**Subject:** Product Improvement – Bariatric CPR Manikin  
(Fat Old Fred) – LF03749 and LF03750

Nasco is pleased to announce the improved redesign of internal structures of the **Bariatric CPR Manikin LF03749 and LF03750** (Manikin formerly known as “Fat Old Fred”).

**LF03777** – Foam Sternum Insert  
Replacement for LF03749 & LF03750  
(Old version without skin)

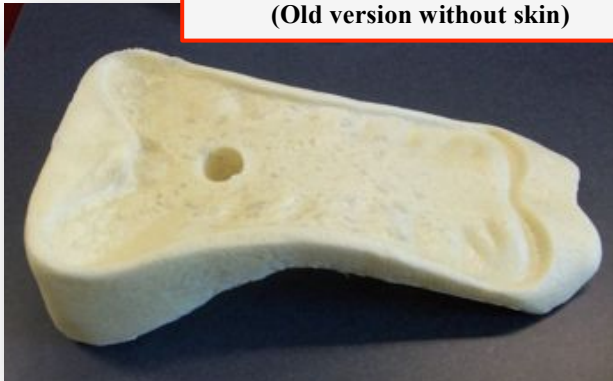
We have upgraded the foam sternum insert (LF03777U) to have a PVC skin to protect it and prolong the life of the product. The new insert has been tested, *without failure*, to 24,000 compressions – a *significant* improvement to the original design. All new Bariatric CPR Manikins will have this feature and all existing stock has been inspected and upgraded to the new version.

**LF03777** – Foam Sternum  
Insert Replacement for  
LF03749 & LF03750  
(New PVC skin to prolong  
product life)
